Agenda
Village of Arlington Heights
Design Commission
Community Room, 3rd Floor

A. DC#16-031 - Kensington School - 840 E. Kensington Rd. -
Commercial

**MINUTES OF
THE VILLAGE OF ARLINGTON HEIGHTS
DESIGN COMMISSION MEETING
HELD AT THE ARLINGTON HEIGHTS MUNICIPAL BUILDING
33 S. ARLINGTON HEIGHTS RD.
JULY 26, 2016**

EXHIBIT A – Approved PUD Site Plan and Landscaped Plaza

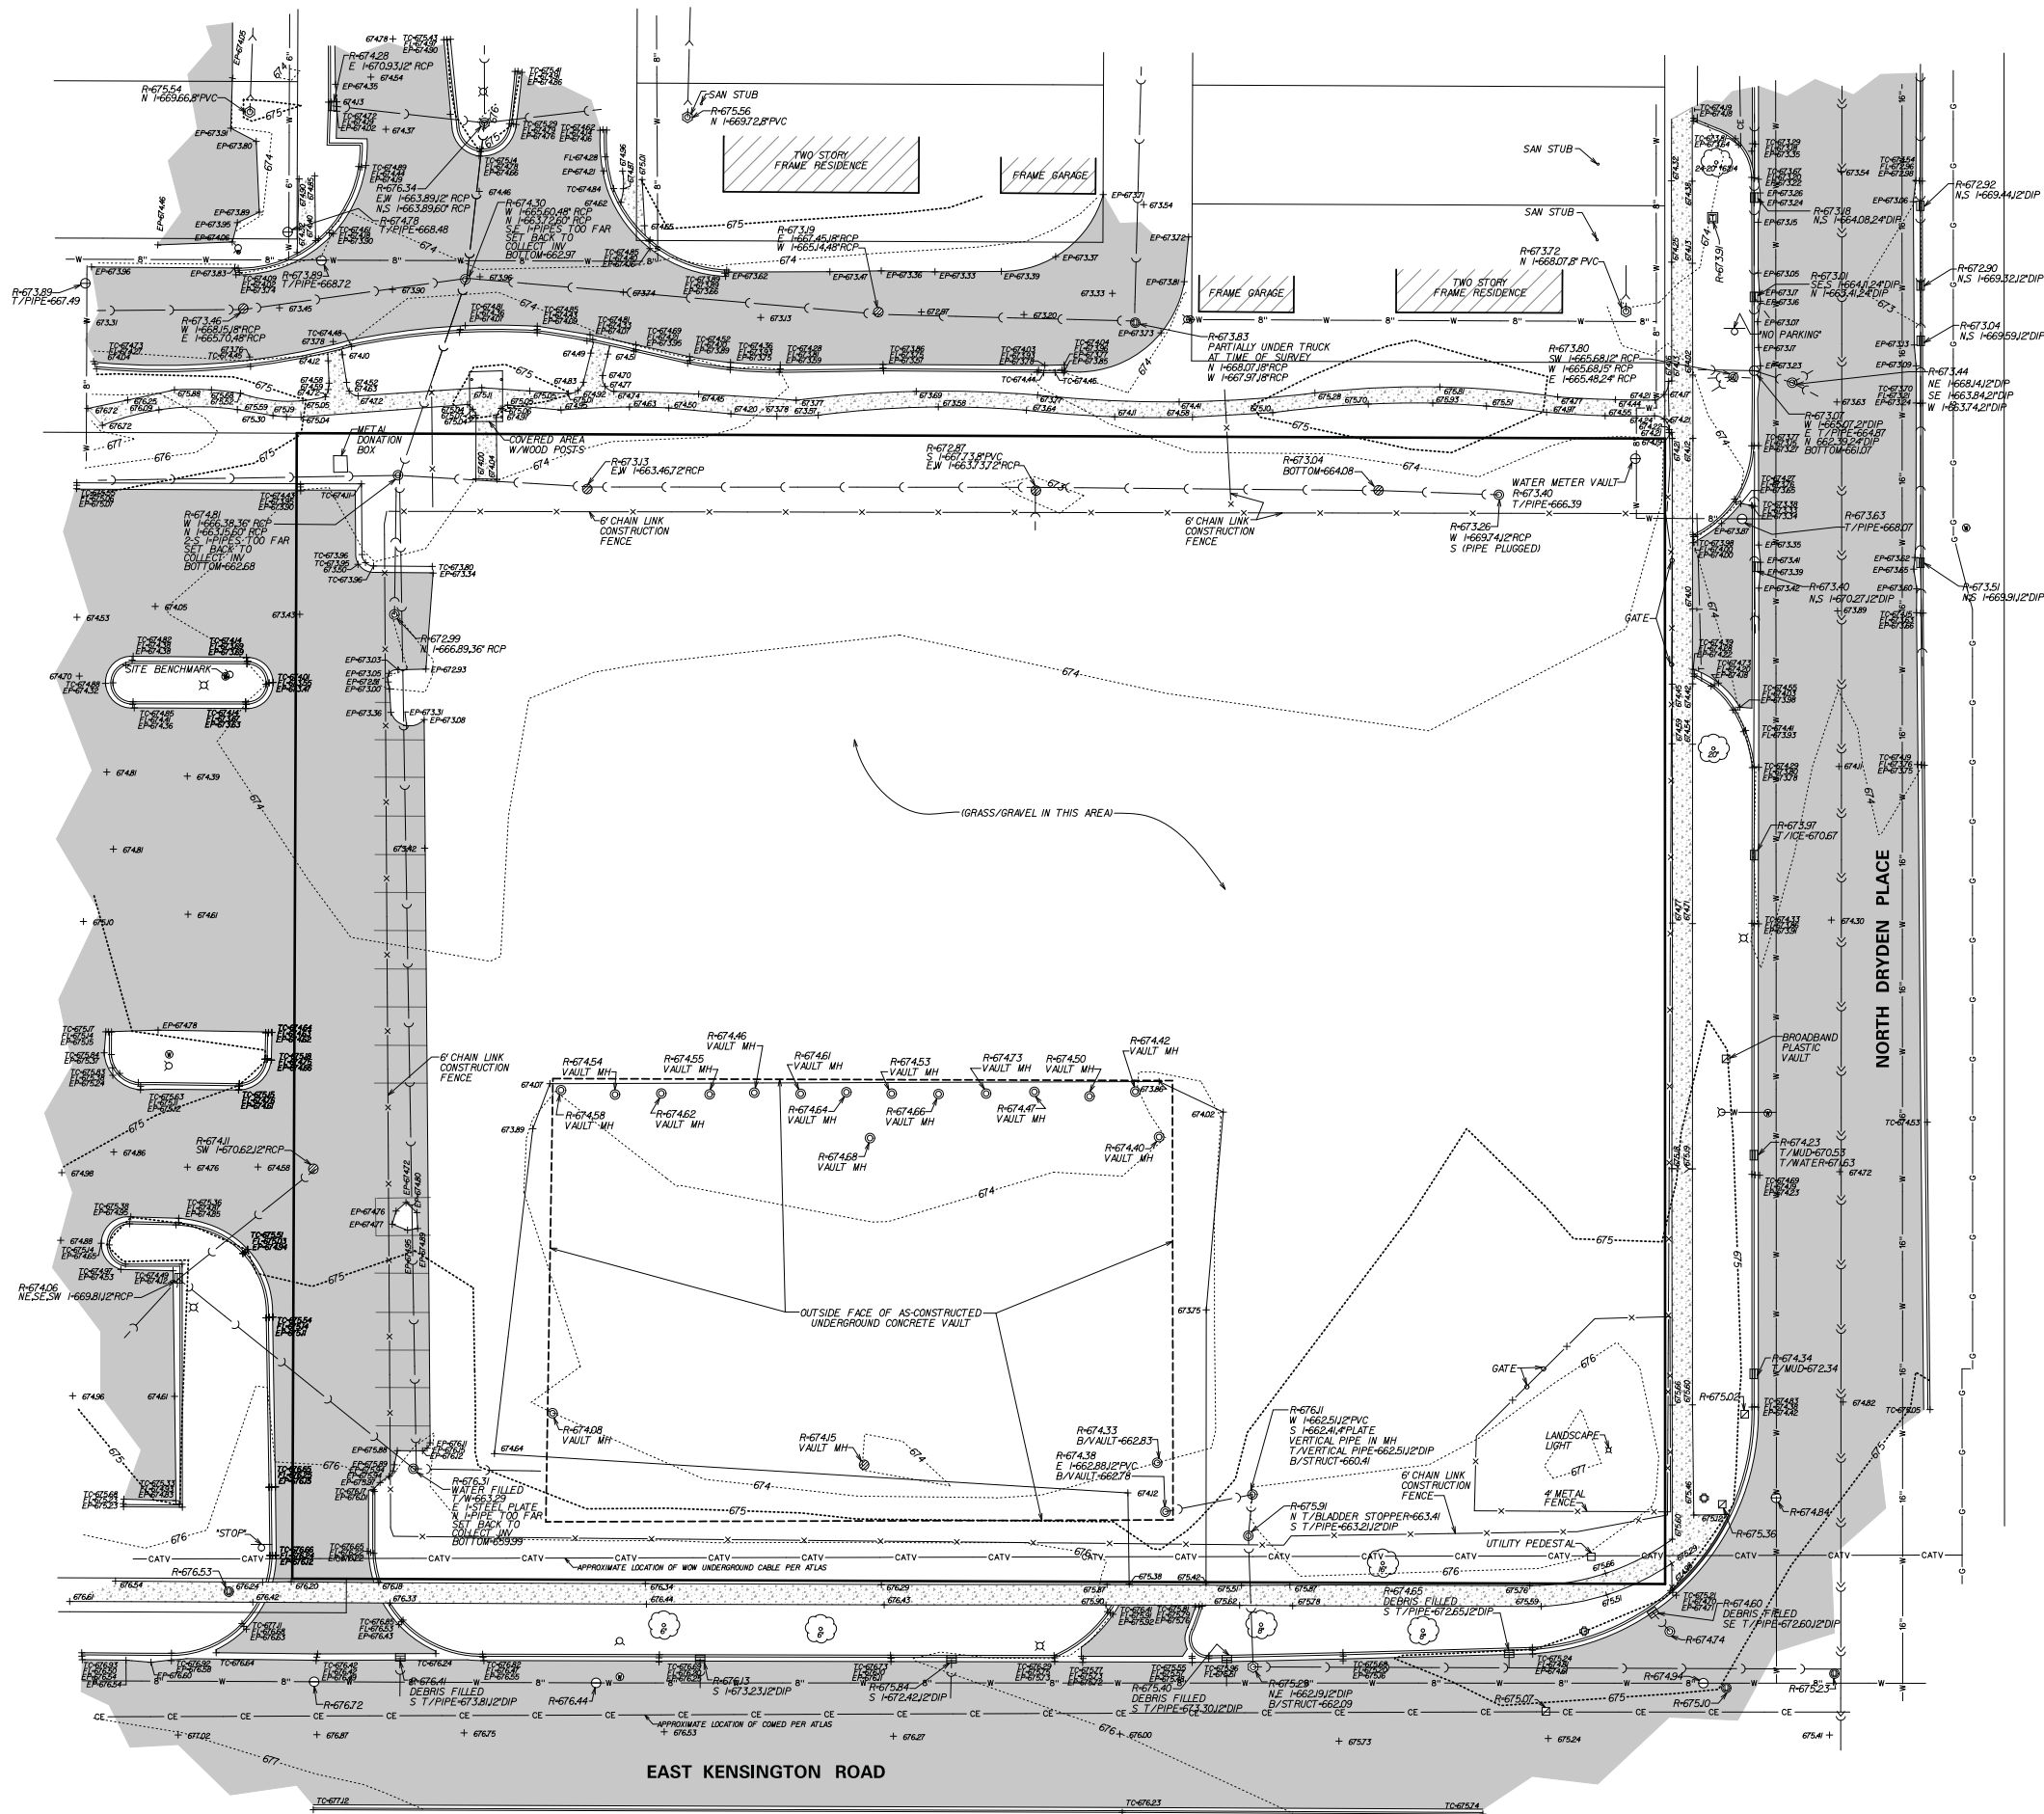
Landscaped Plaza. The original PUD approval included a landscaped pedestrian plaza at the northwest corner of the site to connect the commercial properties to the residential neighborhood to the north. To accommodate this plaza, the Plat of Subdivision includes a 25 foot wide pedestrian access easement which is setback 31 feet from the west property line, and runs 144 feet north to south from the north property line (refer to Exhibit A). This feature is a significant component of the overall master plan for the Arlington Market development, and it was recommended that the Kensington School site design be revised to include it.

SHEET NUMBER:
A-02

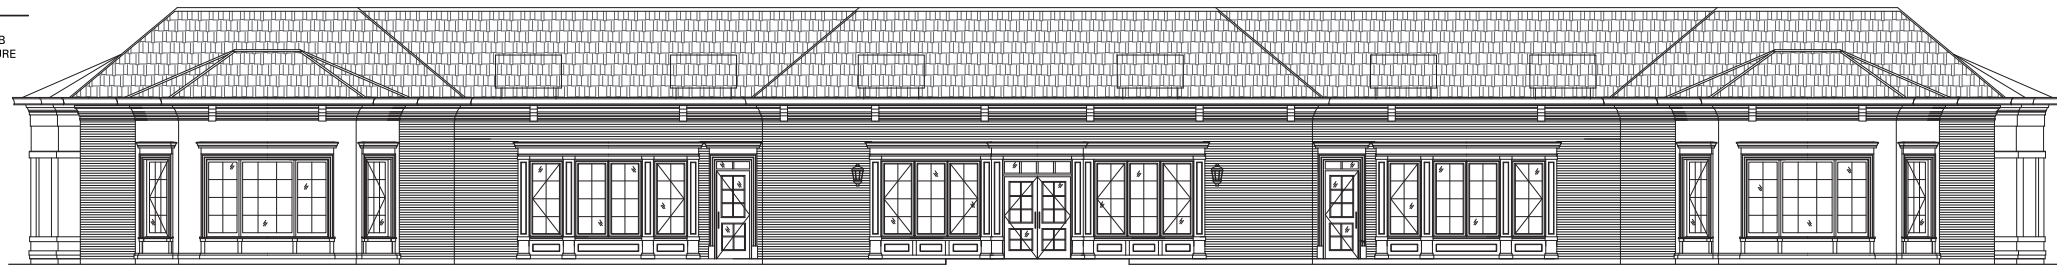
Landscaping. It is recommended that groundcover be added within the center island, and that 3-foot high shrubs be added on the west end of the parking lot between the parking lot and the sidewalk.

Specialty Paving. The Petitioner needs to clarify what the specialty paving within the crosswalks will be, and additional specialty paving is recommended at the building entrance.

8. Add groundcover within the center island.
9. Add 3-foot high shrubs on the west end of the parking lot between the parking lot and sidewalk.
10. Clarify what the specialty paving within the crosswalks will be, and provide specialty paving at the building entrance.

A SOUTH ELEVATION
1/8" = 1'-0"

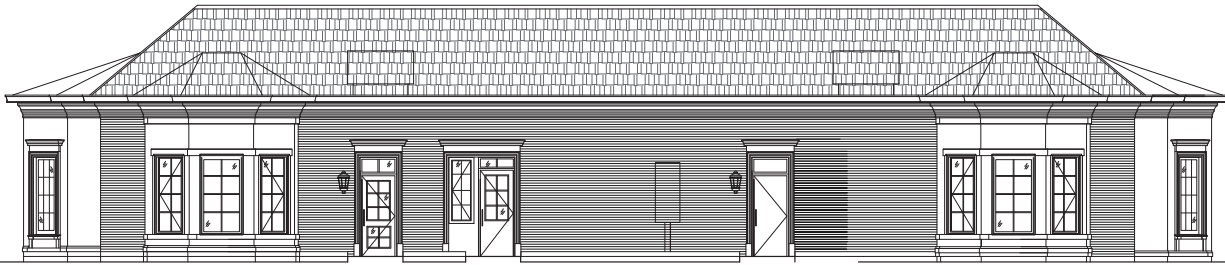
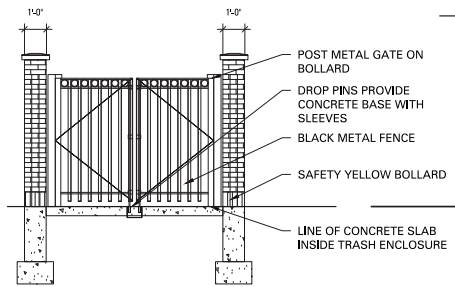
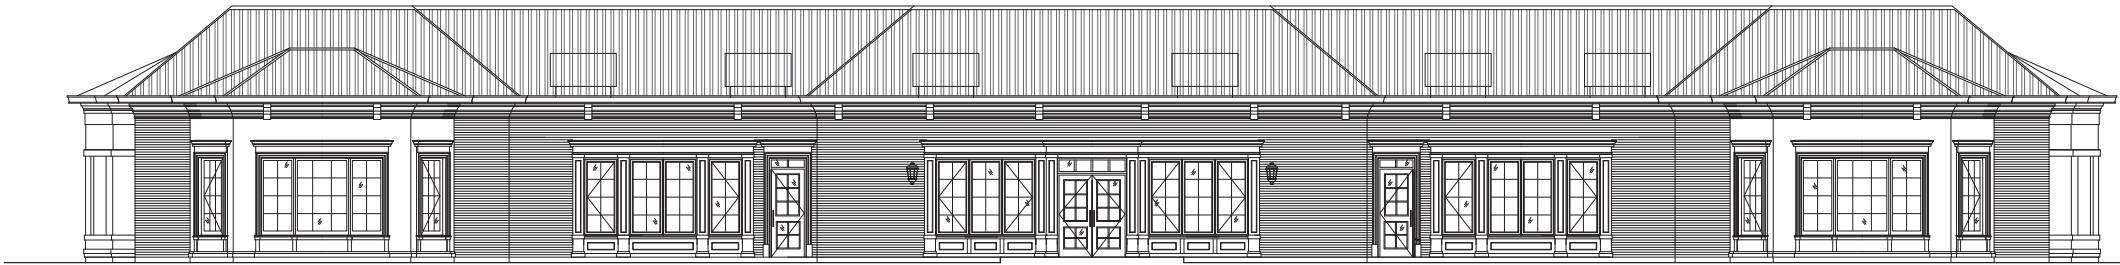
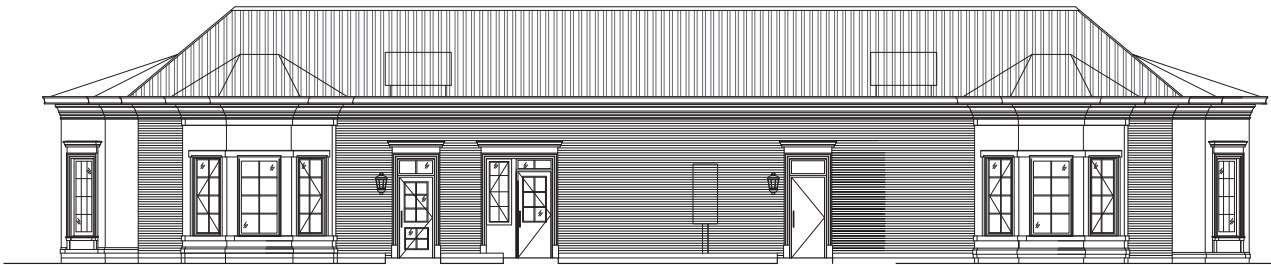
Architectural Design. Staff still questions the appropriateness of the proposed colonial style design in this location. At a minimum, Staff recommends approval of the proposed roofing change from asphalt shingles to a dark gray standing seam metal to help the design relate to the context of the adjacent retail buildings. Staff also recommends changing the white trim to a darker color for a less colonial appearance.

1. The roofing shall be "musket gray" standing seam metal.
2. Consider changing the trim color from white to a darker color.
3. The ground sign shall be limited to 6-feet in height.
